## SD – 045 – Overhead Gate Updated Feb 2022

<b>PROJECT NAME: ATRIUM APARTMENTS – 19945 Brydon Crescent, Langley</b>	<b>DATE: Wednesday, February 9, 2022</b>
---	--

**SUBJECT:** Overhead Gate Shop Drawings

GARAGE GATE SHOP DRAWINGS

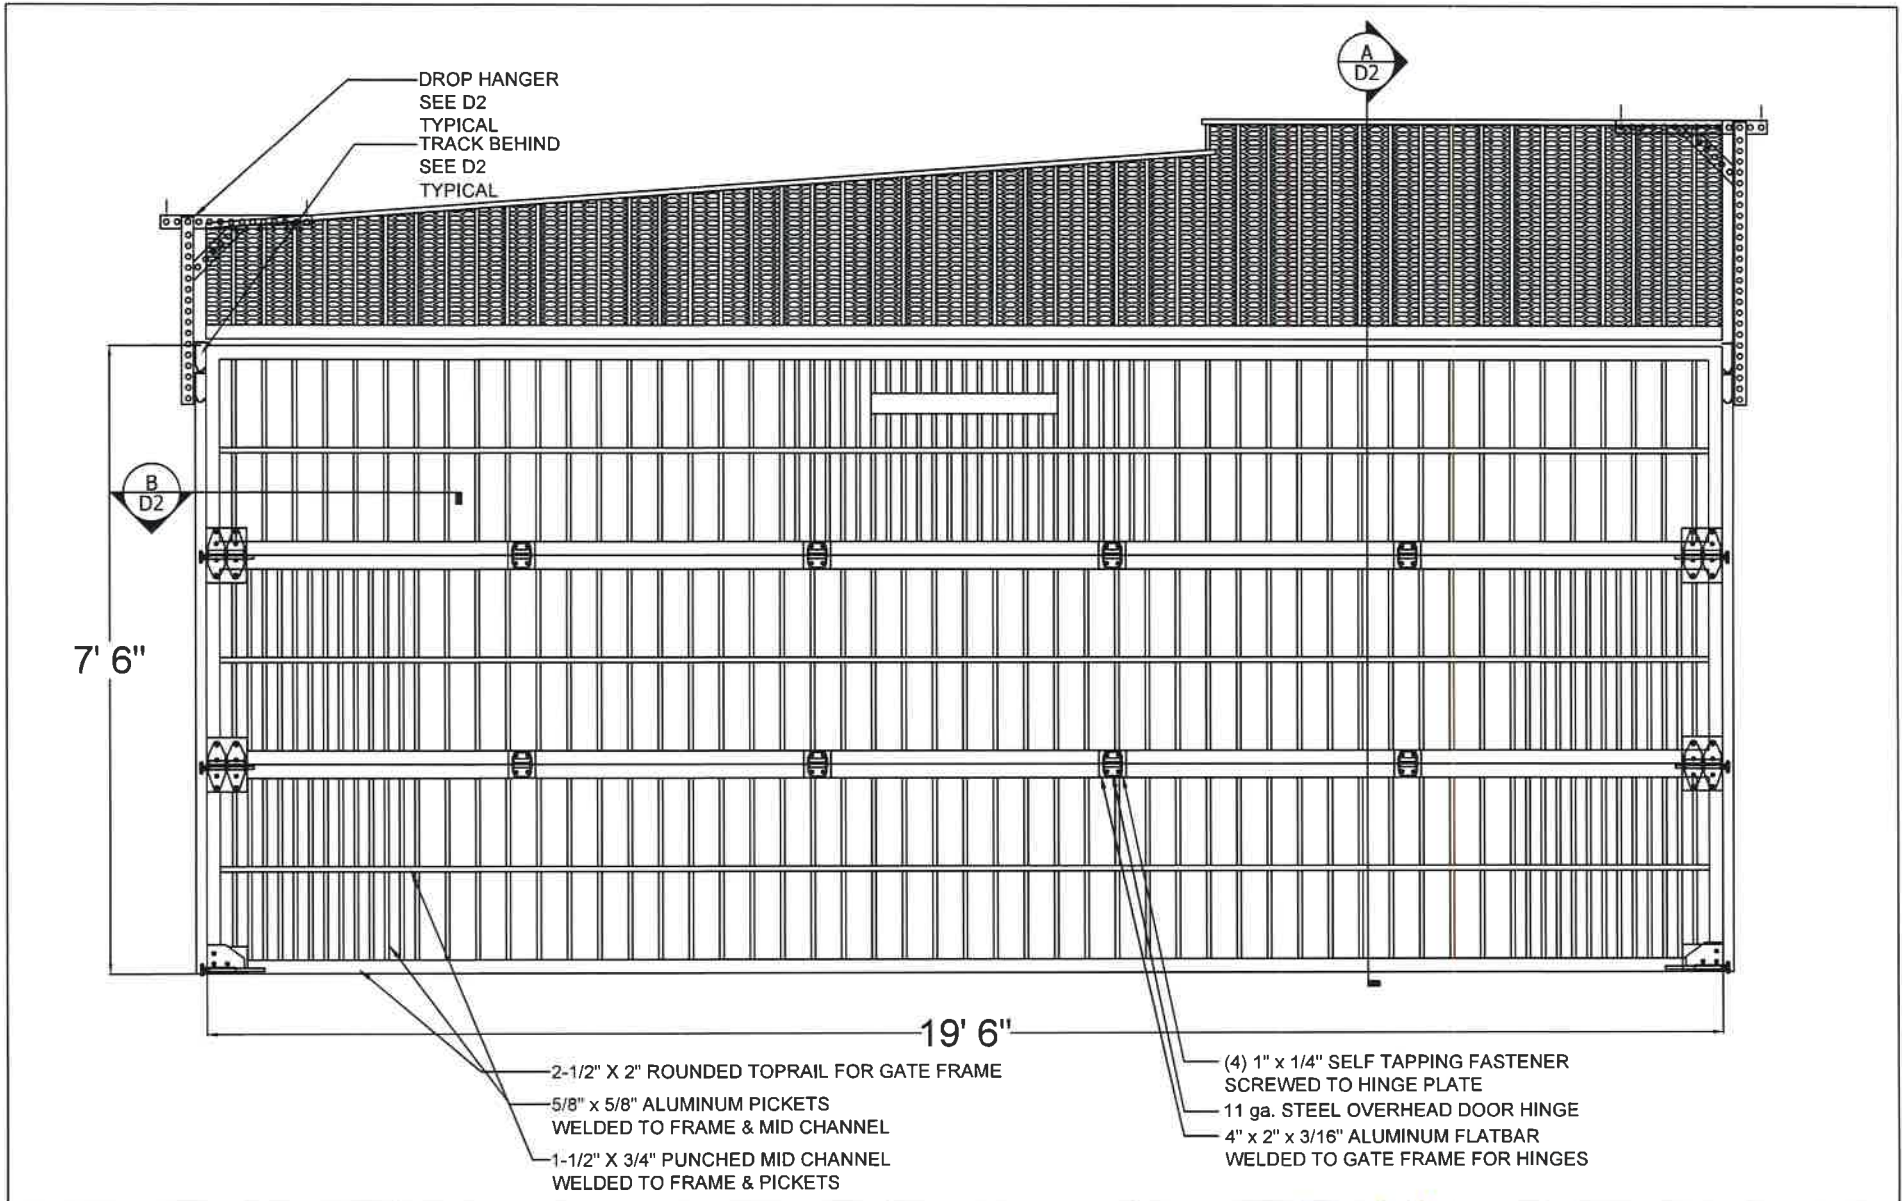
issue one copy to electrical contractor
